### The IEEE Reliability Test System - 1996

A report prepared by the Reliability Test System Task Force of the Application of Probability Methods Subcommittee

## A. W. Schneider, Jr. (MAIN Coordination Center, Lombard IL):

Figure 5 - Single Line Diagram of IEEE One Area RTS-96 Substation System

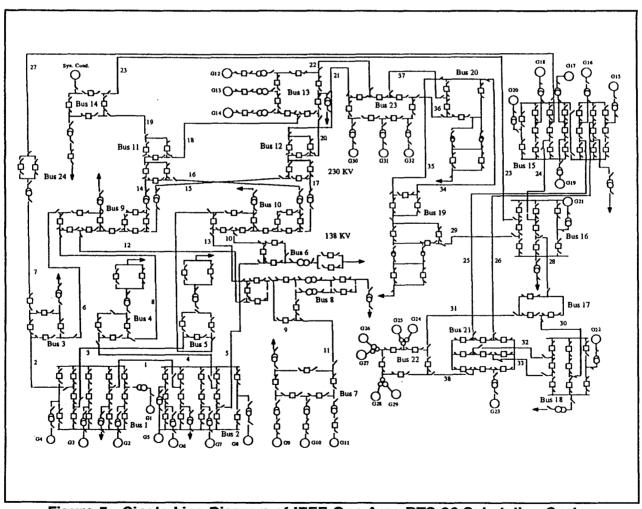
- 2. The capacity of the optional DC line should be shown in Table 13.
- 3. The tap ratio of the generator stepup transformers should be specified in Table 15 or a footnote, even if unity is intended.
- 4. Figure 5 has two omissions which must be resolved to define a valid RTS configuration.
- The connection of the 100 MVAr reactor at bus 6 is not shown.
- The configurations of buses 3, 7, 13, 15, 17, 18, 21, and 23 make no provision for inter area tie line terminations, which do not appear in corresponding buses in every area.
- 5. No outage nor restoration rates are provided for the transformers supplying load, whether 230 kV or 138 kV. Specifying their impedances, tap ratios, and load tap changing characteristics would be a desirable addition.

Several of the substation configurations are more complex (hence, costly) than is needed and at the same time less reliable than simpler alternatives. While it need not be a goal of the RTS to present an optimum configuration at each bus, it is reasonable to avoid redundant breakers and unnecessary exposure to loss of all sources or all outlets to a bus from a single fault. Such exposure may distort the contribution to reliability indices of untypical failure modes.

- An unneeded line breaker connects line 7 to bus 3.
- Distribution system (under 138 kV) data is not generally provided by the RTS. A consistent technique of either showing transformers feeding load, as at but 15, or omitting them as at but 20, should be adopted. Paralleled breakers and/or transformers, as at buses 6 and 8, raise issues for which the RTS data is completely inadequate.

- The configurations of buses 9-12 are unnecessarily complex and unreliable. All these buses have the "supplies" grouped on one side of a critical element and the "loads" grouped on the other side. Loss of the common element will result in total interruption of supply from the 230 kV to the 138 kV system through the affected bus. Configuring each of these buses as a simple ring bus would be less costly and more reliable.

- Similarly, bus 8 has its sources from buses 9 and 10 grouped together and is susceptible to isolation by a single event.
- At bus 22, exchanging the connection of G26 and G27 with line 38 would eliminate the possibility of all generation at this station being lost from a single fault on a breaker.
